Re: LMA H-149, Glenmont Forest Investors, LLC

Project: 2024 Wallace Ave/ Case # LMA H-149 Glenmont Forest Investors, LLC
Location: 2024 Wallace Ave, Silver Spring, Maryland
Project #: 240311-1

Figure 3. Mr. Takamoto's Approximate Location of SWM Channel

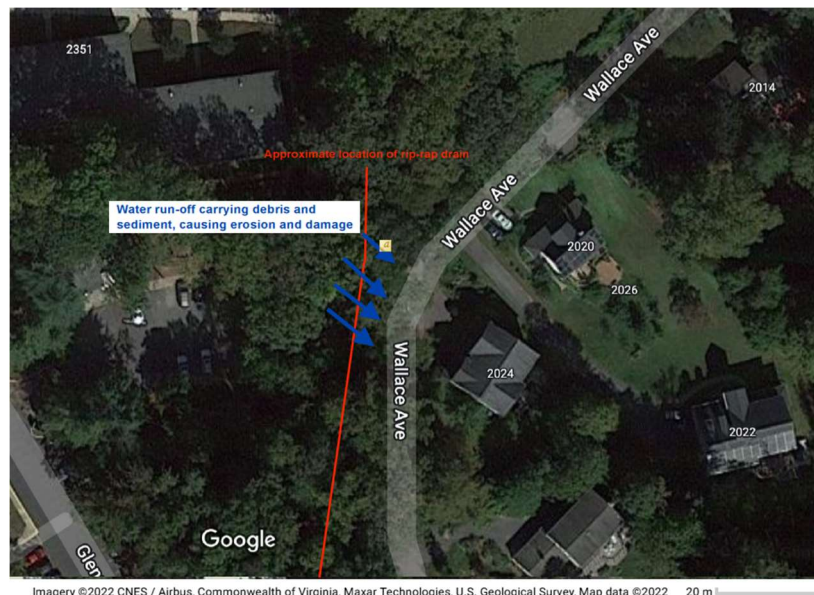
Based on the topography on the preliminary design plans, the Glenmont site is at a higher elevation than Mr. Takamoto's property and has a large drainage area from the apartment property directing stormwater runoff toward Mr. Takamoto's property and toward a natural stream bed to the south of the property, running east to west. According to Mr. Takamoto, there is an open channel that intercepts and directs this drainage area along the border of the two property lines; an approximate location of the channel (annotated as "rip-rap drain") and additional notes and labels provided by the homeowner is depicted in Figure 3. Historically, this drainage area and the quality of the channel has created problems including but not limited to: excessive stormwater runoff volume, sheet flow and channel flow onto and around Wallace Ave and Mr. Takamoto's lawns, severe erosion from the steep slopes (>15%), and ponding near structures vulnerable to groundwater infiltration; these issues and damages have been documented by Mr. Takamoto as early as 2008. Further investigation into the history of damages, based on the photographs taken by Mr. Takamoto, revealed that the Glenmont property's small open channel, which was stabilized in June 2023 with additional rip-rap (stones) by the owners of the Glenmont Apartments, had failed to directing runoff in April 2024. Reportedly, the rip-rap channel was repaired within the month; it is unknown the extent or the type of repair that was performed.

Figure 4. Excerpt of The Glenmont Site's Preliminary Plan Adjacent to Takamoto Property

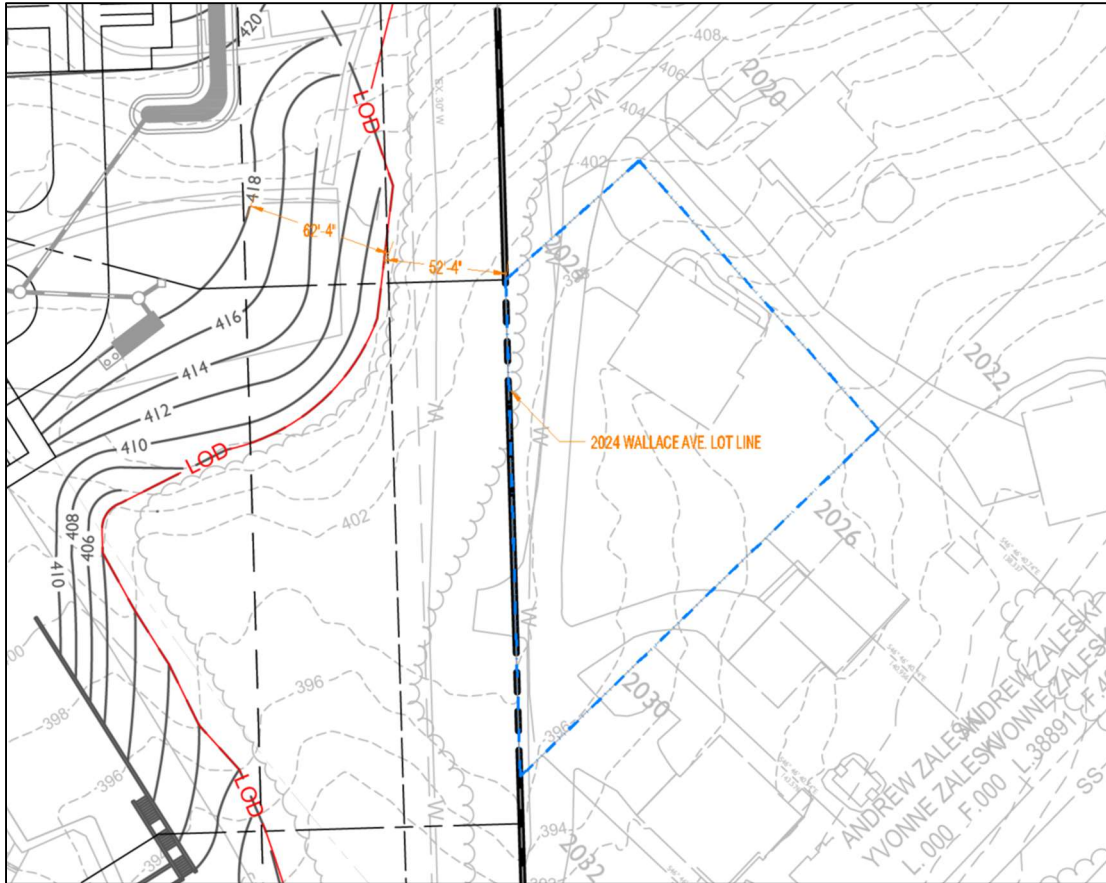
Based on the Preliminary Forest Conservation Plan, which includes preliminary alterations to the grading and new stormwater management systems, a large area of fill is planned near the Takamoto property which will increase the length of the steep slope directing runoff onto the Takamoto property. Figure 4 shows the preliminary grading alterations – (indicated by the topographic solid black lines) near the Takamoto property (indicated by the blue dashed boundary). The existing grade topography is represented by the lighter gray dashed lines. Figure 5 shows a cross-sectional view of the grade comparing the original grade and slopes with the proposed grade and fill northwest of the Takamoto property line.

Elongating a steep slope without breaks increases issues with soil erosion and will lead to high velocity stormwater runoff onto the Takamoto property. Even with the aid of

reforestation of the upper portion of the slope, it will take many years before the full benefits of soil-stabilizing root systems are realized.

1. Remain vigilant in documenting stormwater runoff sheet flow, channel flow, soil erosion, any damages to plants and trees, any damages to the asphalt roadway, and any other storm-related damages with date stamped photographs and videos.
2. Provide Glenmont developers with this report to reiterate the importance of designing a stormwater system that will eliminate any drainage area from their site onto the Takamoto property and the importance of addressing the >100 ft run of steep slopes (>15%).

3. Request from the Glenmont developers the preliminary Erosion and Sediment Control Plan (ESC), Grading Plan, and Stormwater Management Plan for a limited peer review as it relates to the effects on the Takamoto property.
4. Remain vigilant in reporting erosion and sediment issues, especially during the construction phase, to the Montgomery County Department of Environmental Protection using their 3-1-1 hotline (or 240-777-0311 if outside the county) and filing an erosion control complaint to resolve the problem as quickly as possible.
